**Virginia Stormwater Best Management Practice (BMP)  
Clearinghouse Committee Meeting**

Virginia Department of Forestry Building, Training Room  
Charlottesville, VA  
October 22, 2012

Meeting minutes by Jane Walker

**Figure 3.1. Flow chart illustrating the approval process in Virginia for stormwater manufactured treatment devices.**

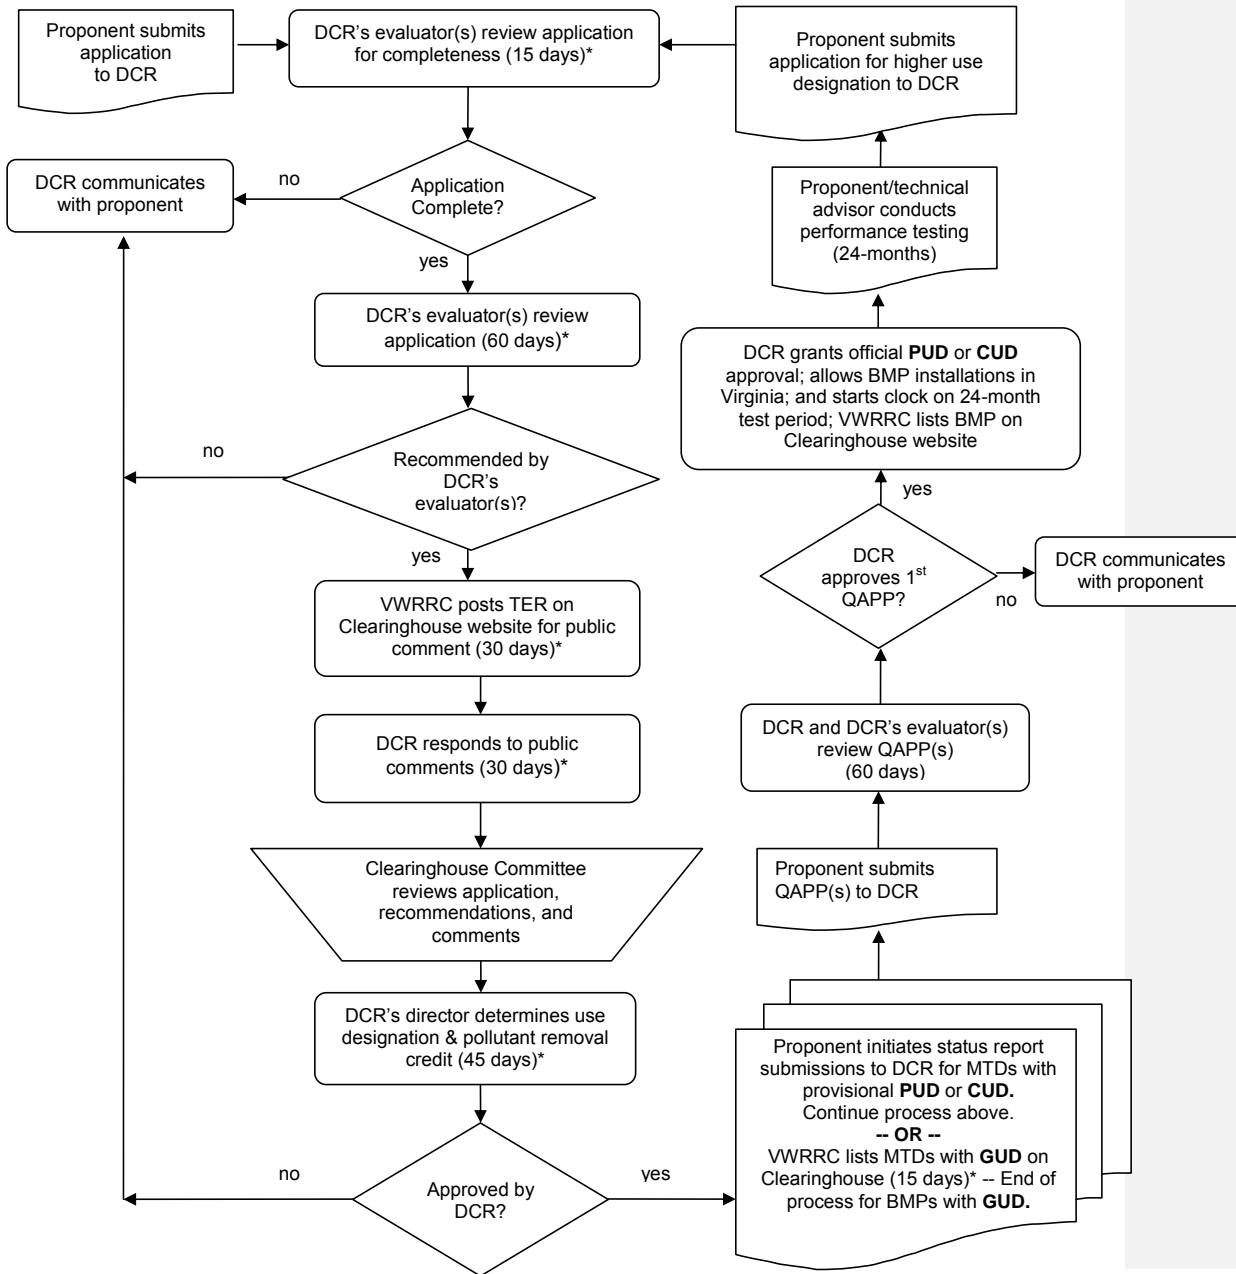
Comment [WJ25]: Public Comment #14

**DELETE THIS Figure 4.1. Sample Effort Needed for Paired Testing (Power of 80% and Confidence of 95%) (source: Day, Pitt, and Parmor 1997)**

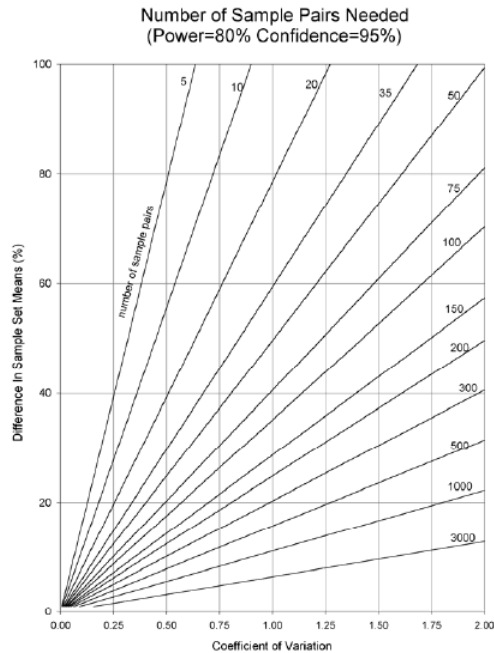
David Sample explained that Figure 4.1 (sample effort needed for paired testing) was removed from the VTAP. It had previously been included to help explain the reason for monitoring sequential storms but was being removed because it raised several questions from the public thereby causing more confusion than clarification. He added that only 18 qualifying storms are needed if the confidence level exceeds 50% and if approved by DCR; otherwise 24 qualifying storms must be sampled. David Sample noted that the VTAP has relaxed the "ten consecutive storm" requirement to five paired storms (for a total of ten events), which consist of back-to-back

Comment [WJ31]: Public Comment #28:

~~Graphical plots developed by Burton and Pitt (2002) can be used to estimate sample size. The graphical plots are based on a statistically based process known as a power analysis. [The graphical plot in Figure 4.1 may be used to estimate the sample effort needed for paired testing, (i.e., for the purpose of the VTAP, comparing the influent and effluent loads of TP) testing back-to-back/sequential storm events). The methodology produces a minimum required number of samples necessary to meet a desired coefficient of variation on the order of magnitude of hundreds of storm events. However, a critical assumption of the statistical method is that events are independent, i.e., the performance of the MTD is not impacted by previous events, nor does current performance impact later events. Because we know that behavior of the system is, in fact, related to what occurred during prior events (due to pollutant capture and buildup), understanding the behavior of the system and its response to these events becomes critical. This influence from previous storms becomes a strong argument for requiring an increased number of samples and ultimately for sampling a relatively long continuous sequence of storm events.~~

Figure 4.54. Illustration of effluent probability method for assessing ~~efficiency-pollutant removal~~ of stormwater ~~manufactured~~ treatment devices

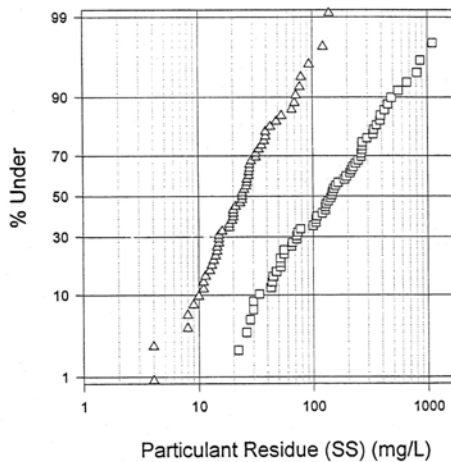
Comment [WJ55]: Addressing Public Comment #28
